DRAFT REPORT

2nd meeting of GRRF Informal Working Group on Automatically Commanded Steering Function

Venue: Jasic Office Tokyo, Japan.
Chairman: Mr. Christian Theis (D) and Mr. Hidenobu Kubota (J)
Secretariat: Mr. Jochen Schaefer (CLEPA)
Dates: 16.-17. June 2015
Website: <https://www2.unece.org/wiki/display/trans/ACSF+2nd+session>

5. Attention recognition (2.4.8.13)

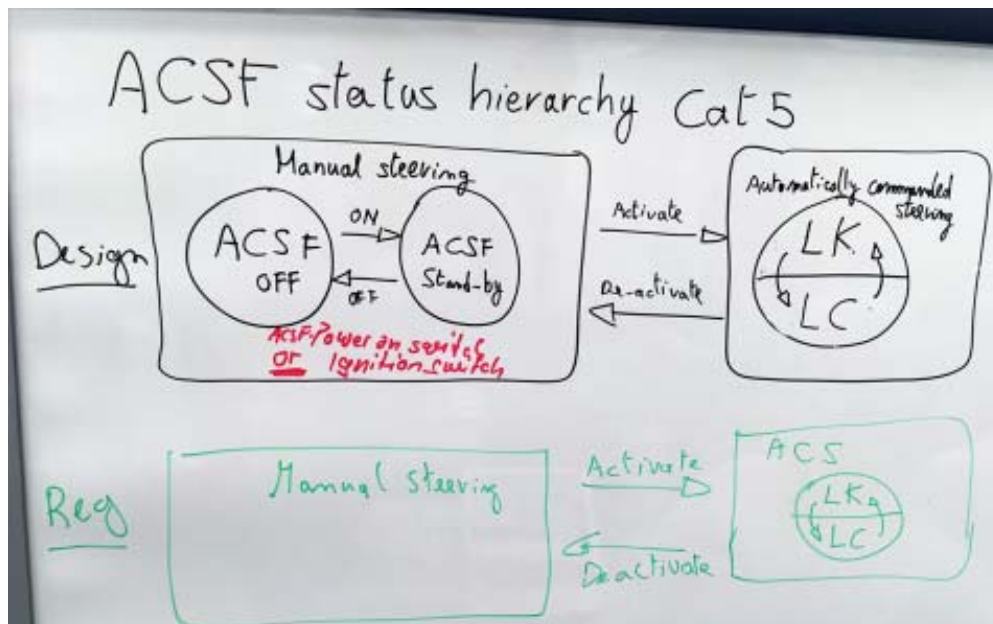
OICA: Attention of the driver cannot be detected.

Only "secondary criteria" e.g. closed eyes, looking to the side, can be detected
